ARCHITECT'S ADDENDUM

Addendum Number: 01

RE: Rantoul Forum Fitness Center

Subject: Addendum No. 01 to the Construction Documents for the Bid Set.

1 FIRST FLOOR LIFE SAFETY PLAN
 3/32" = 1'-0"

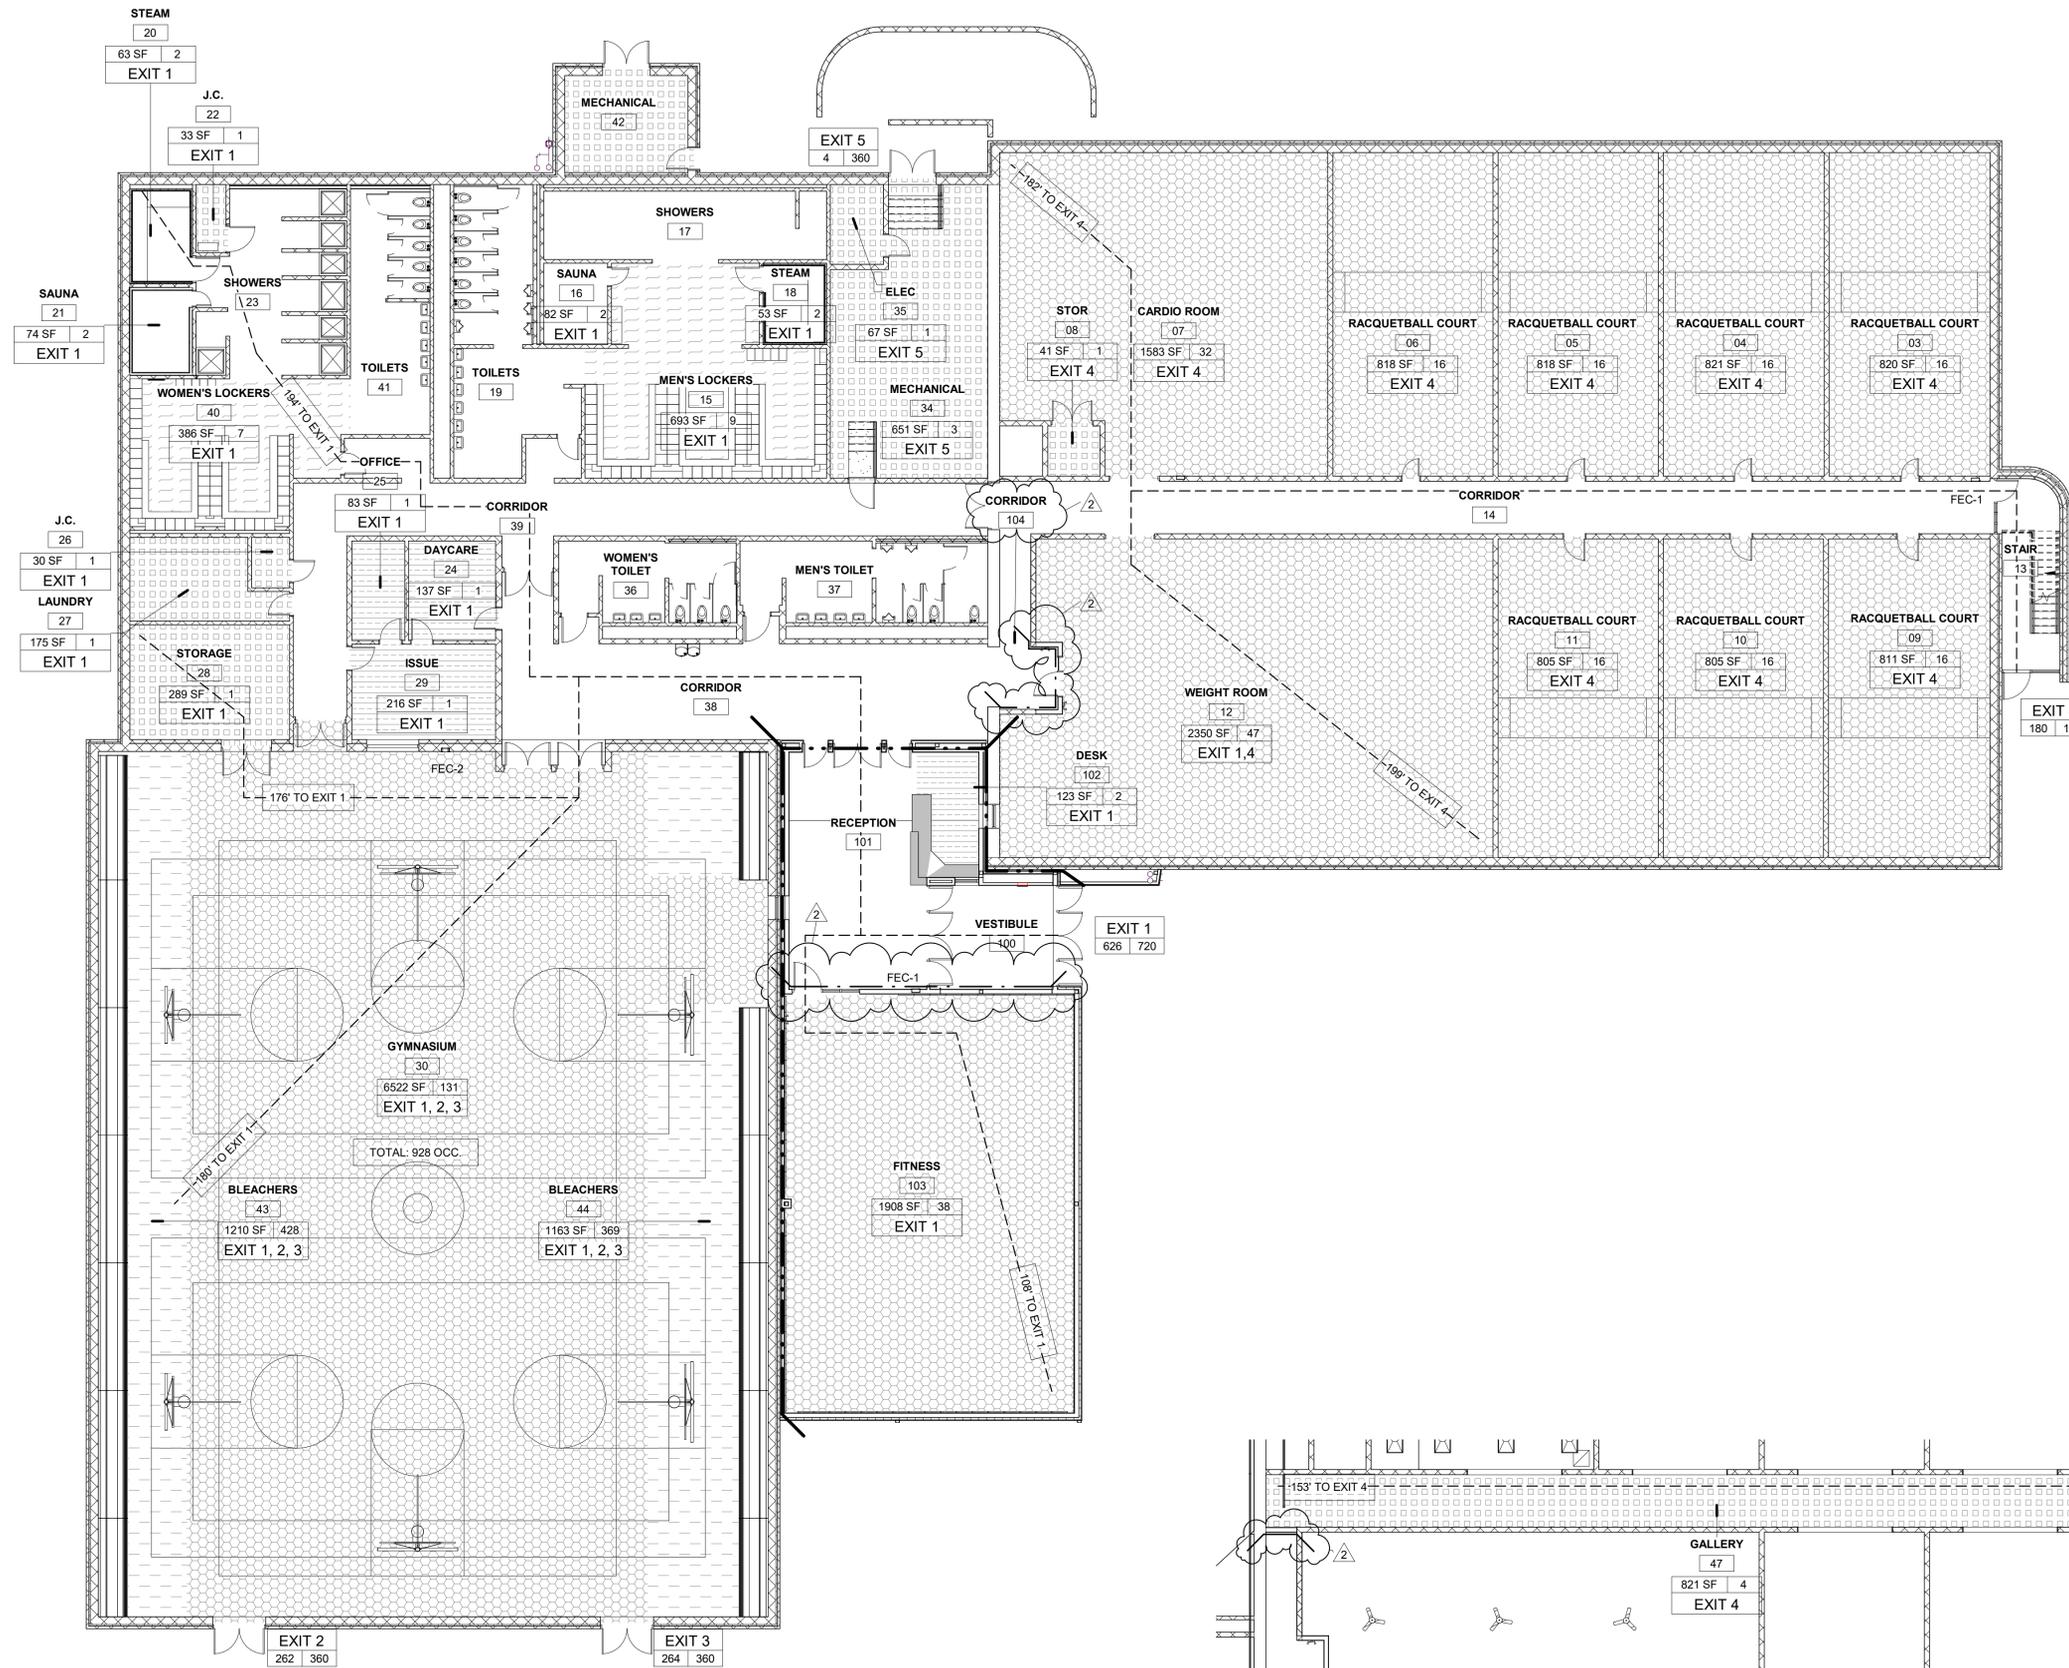
T2.1 – Addition of a 1-hour fire partition between Fitness 103 and Reception 101 and Vestibule 100. Also, addition of a 1-hour fire partition in Corridor 104.

1 FIRST FLOOR PLAN
 3/32" = 1'-0"

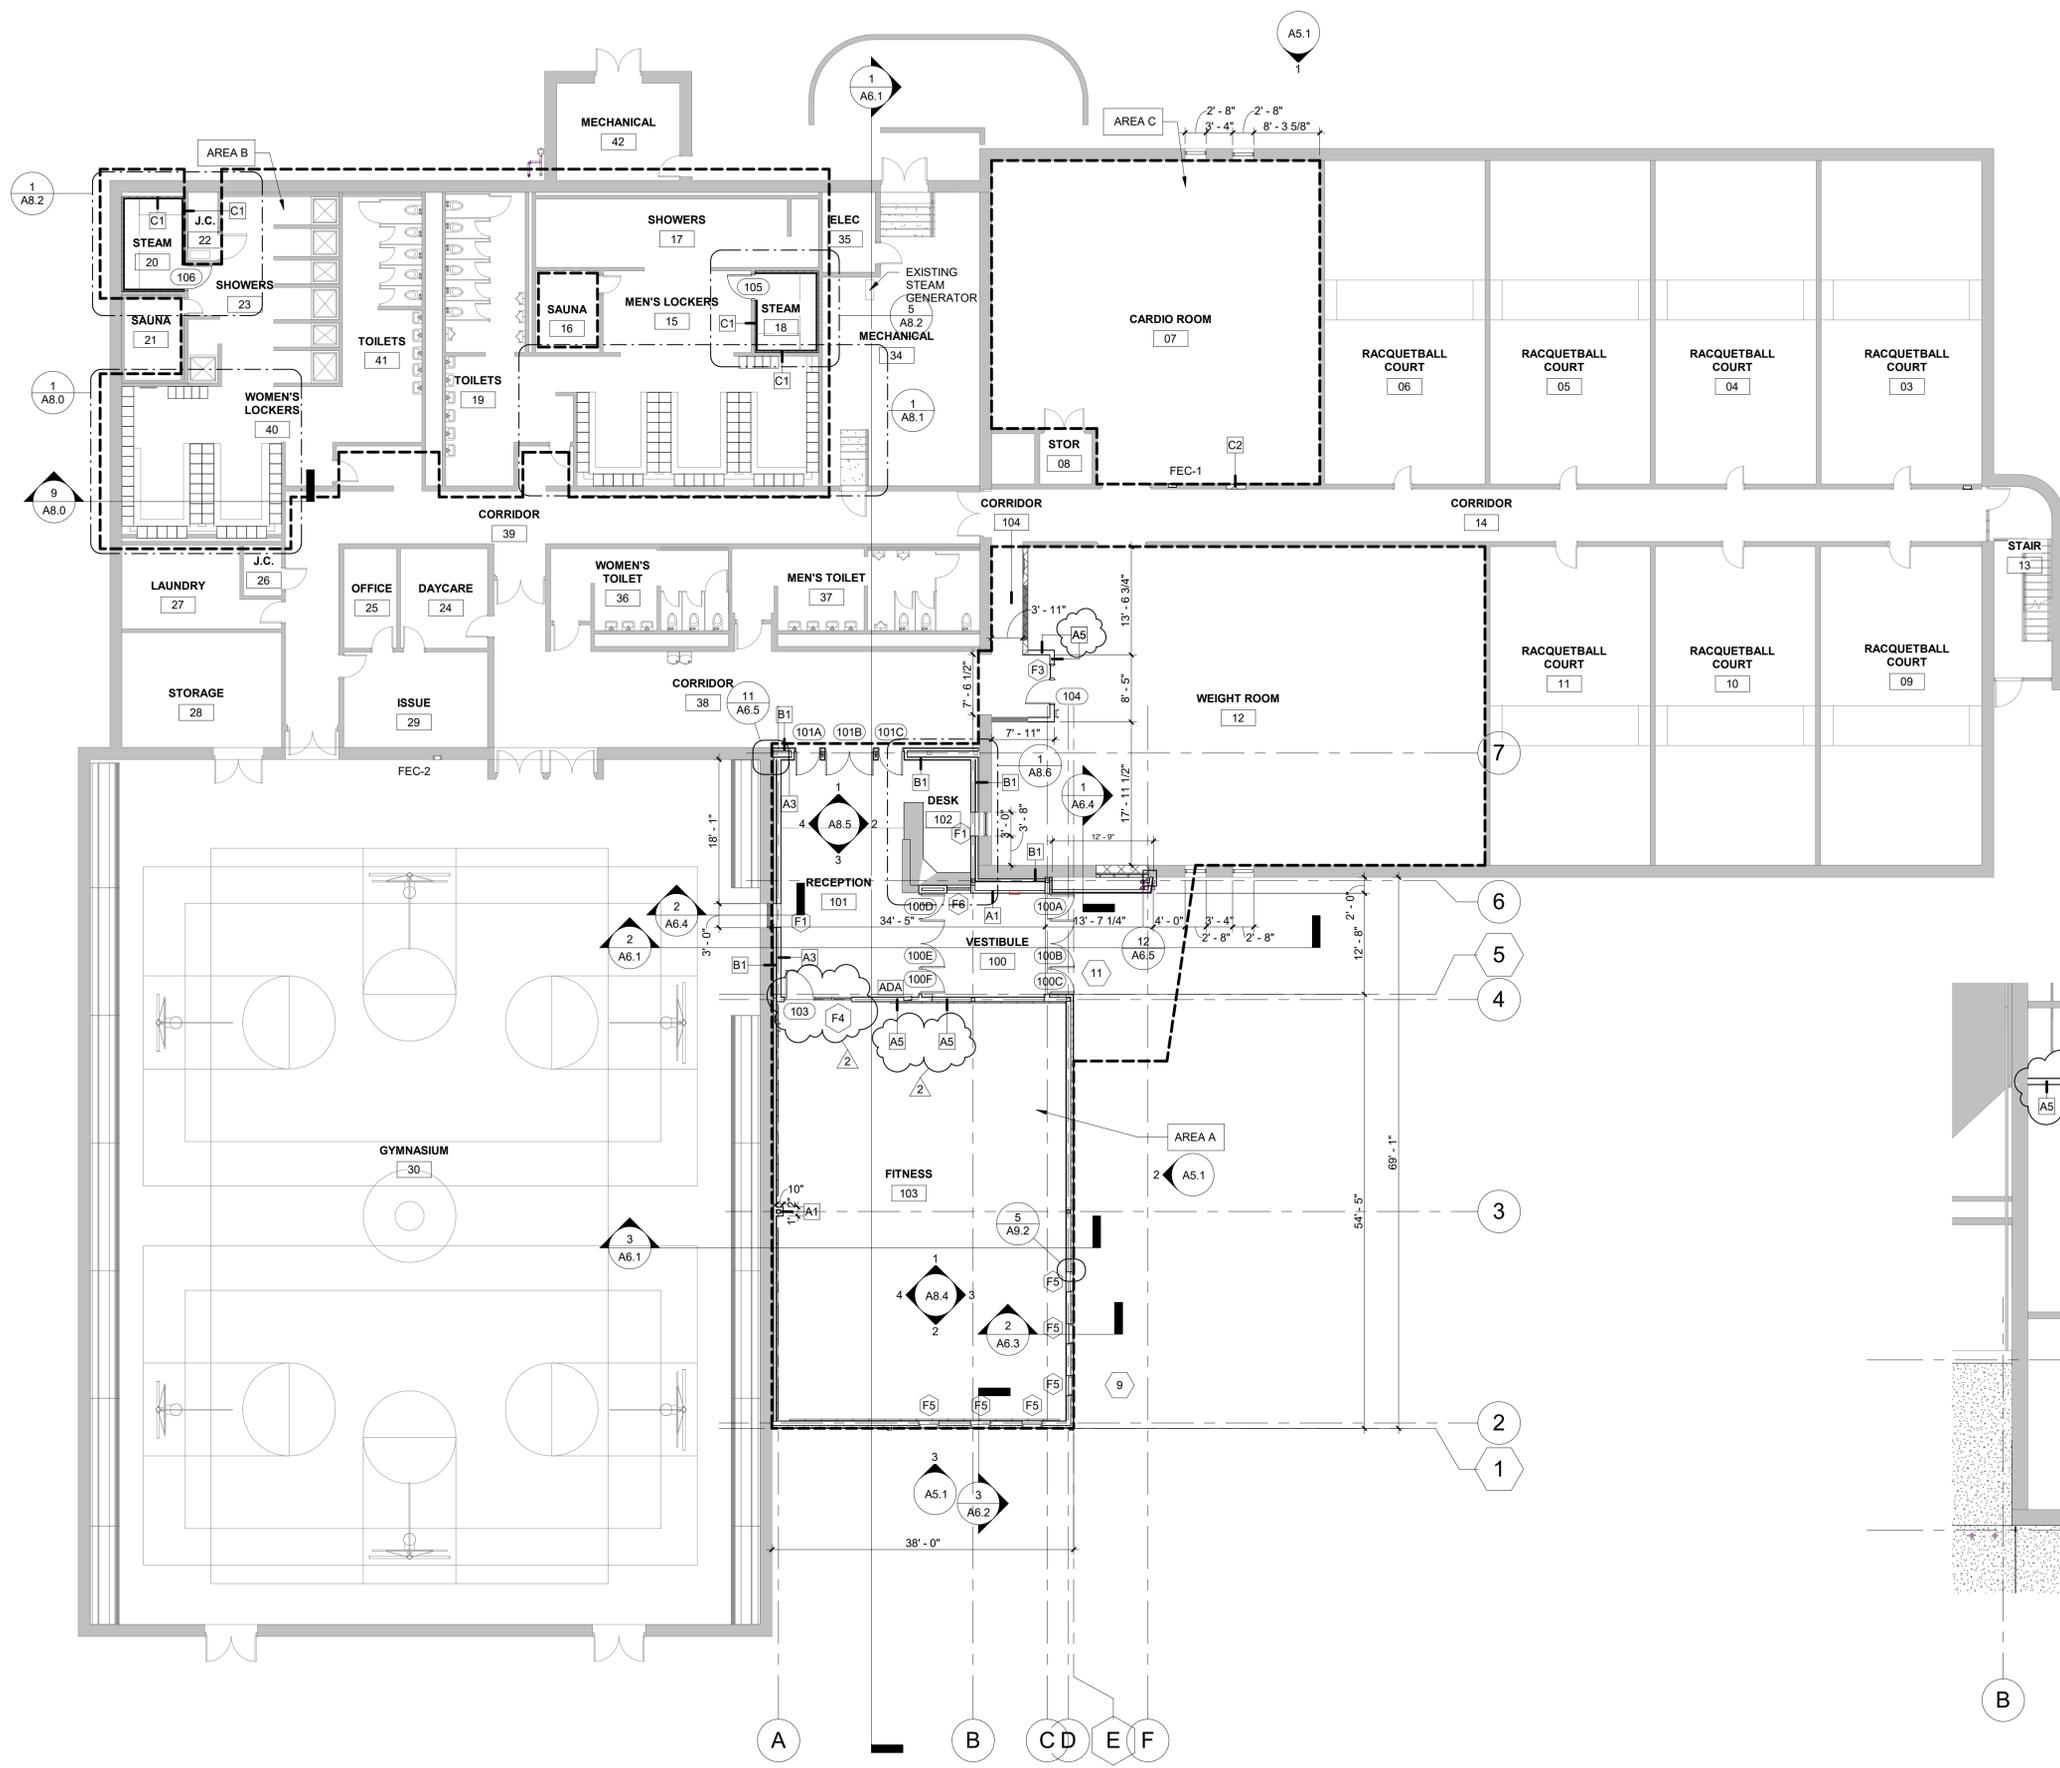
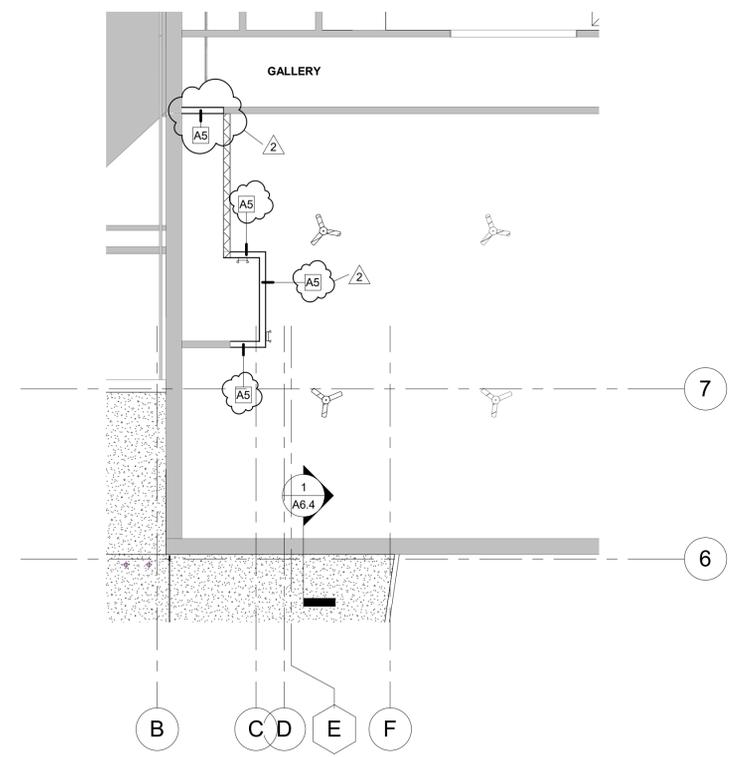
A2.1 – Revision of partition types to A5.

WALL TYPE A - INTERIOR WALL

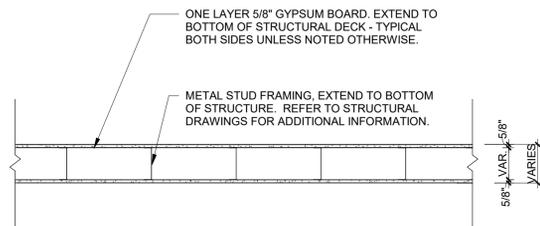
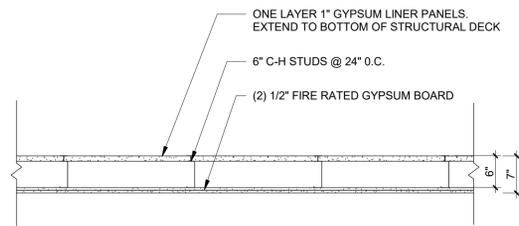
A2.2 – Addition of partition type A5, 1 hour rated fire partition.

1 WALL TO FLAT ROOF DETAIL
3" = 1'-0"

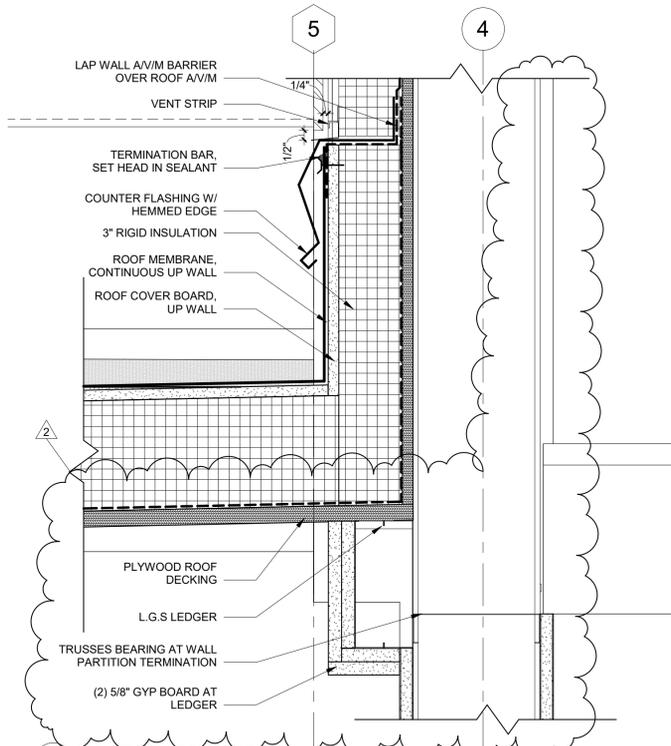
A6.2 – Revision to detail 2/A6.2 denoting type-X gypsum board to be continued to bottom side of roof deck at fire rated partition.

1 WALL SECTION AT FIRE WALL
 3/4" = 1'-0"

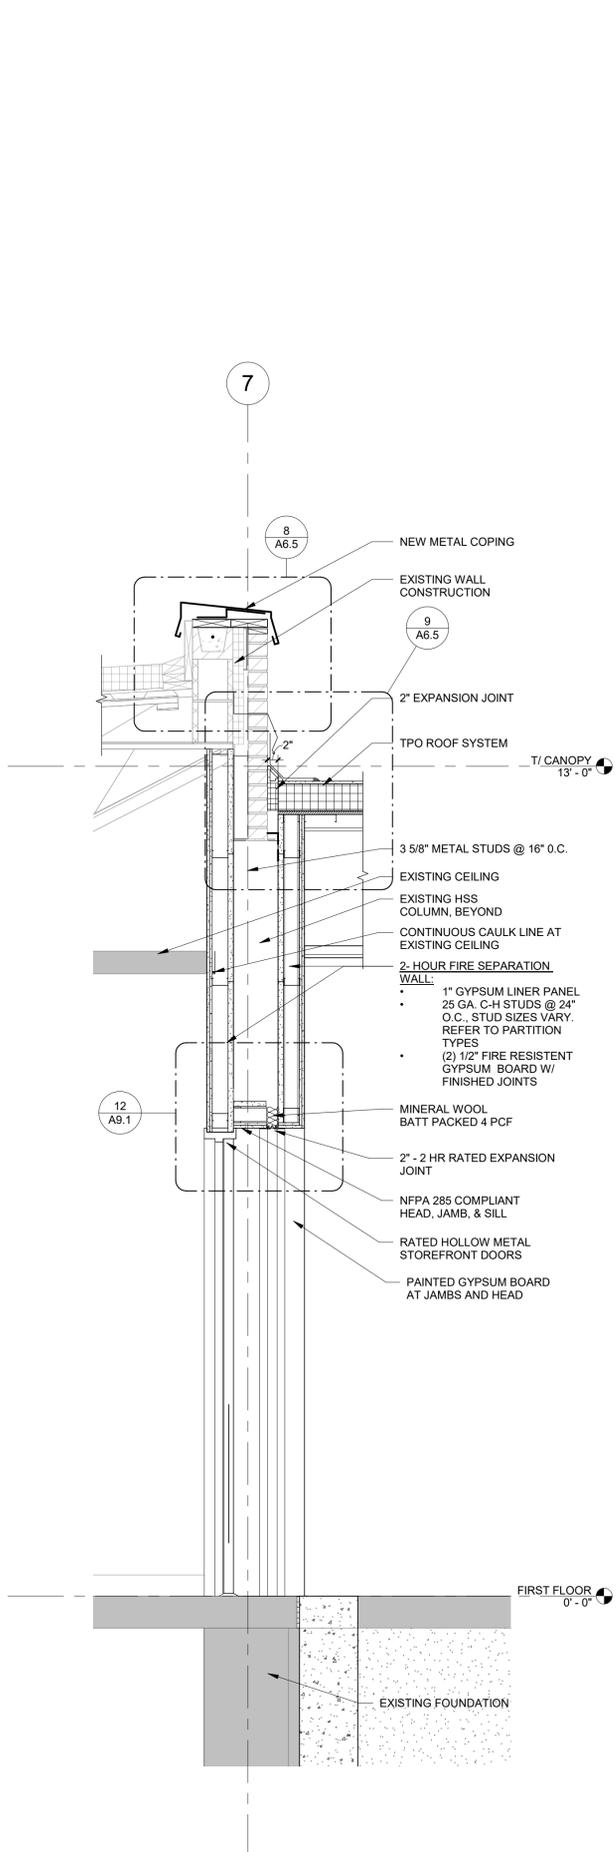
A4.2 – Revision to Detail 1/A4.2. Partition A5 terminates at lower roof.
